29 October 2020

Reference: 200783.01FA

TRAFFIC AND PARKING PEER REVIEW OF ALTERATIONS AND ADDITIONS TO MANLY BOATSHED AT 1B BOLINGBROKE PARADE, FAIRLIGHT NSW

FIGURE 1: AERIAL IMAGE OF SITE ON 26/09/20 BY NEARMAP

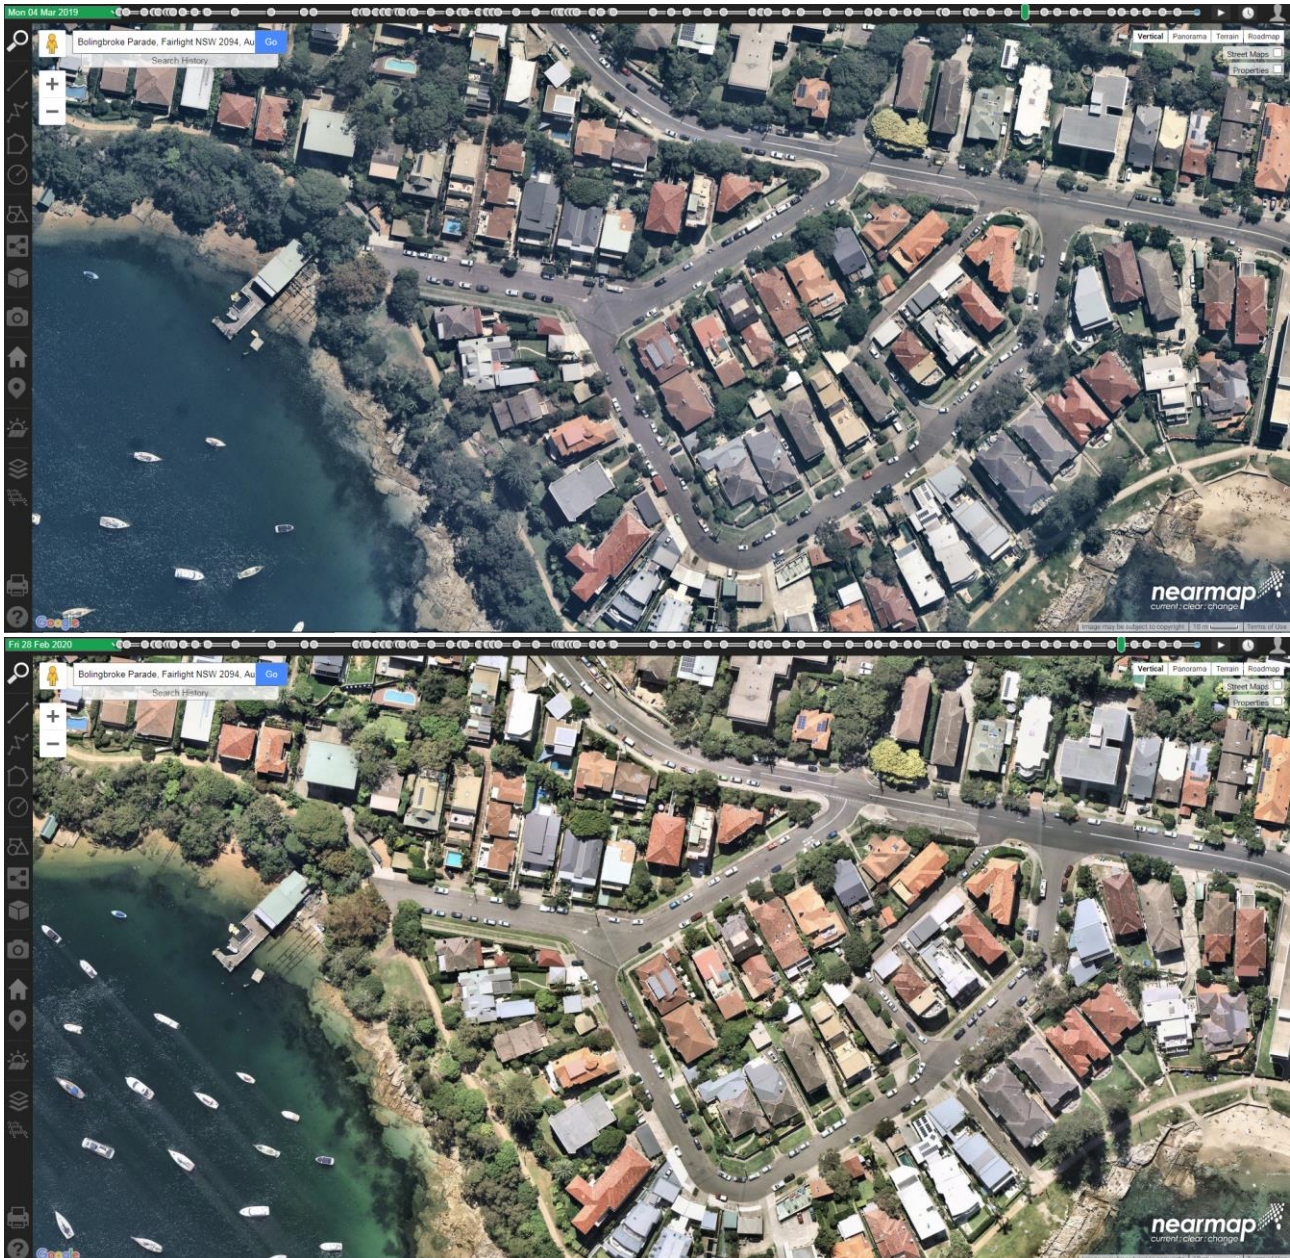
The TIA does not provide a parking survey of nearby parking supply nor changes in availability through the peak operating times of the development. It is unknown the number of spaces available within the vicinity of site and how any of those spaces are impacted by duration of stay restrictions. The TIA makes a qualitative assessment based on some “a review of aerial photography over multiple days” and then proceeds to neither list which days of the week, which periods of the year or which times of times those images were taken. In doing so the TIA presents a baseless analysis of the potential impacts of the existing development and proper function of the surrounding parking environment. This firm has conducted a similar aerial photography desktop review and as shown in **Figure 1**, on the 26th September 2020 there was zero spare parking available within 200m walking distance of the site and that additionally there are several cars parking over the verge in driveways such that more than 100% of the public parking is being used. This is an obvious difference to that existing situation described in the TIA and leads to a low level of credibility of the TIA. Additional days of imagery are provided in **Annexure A**.
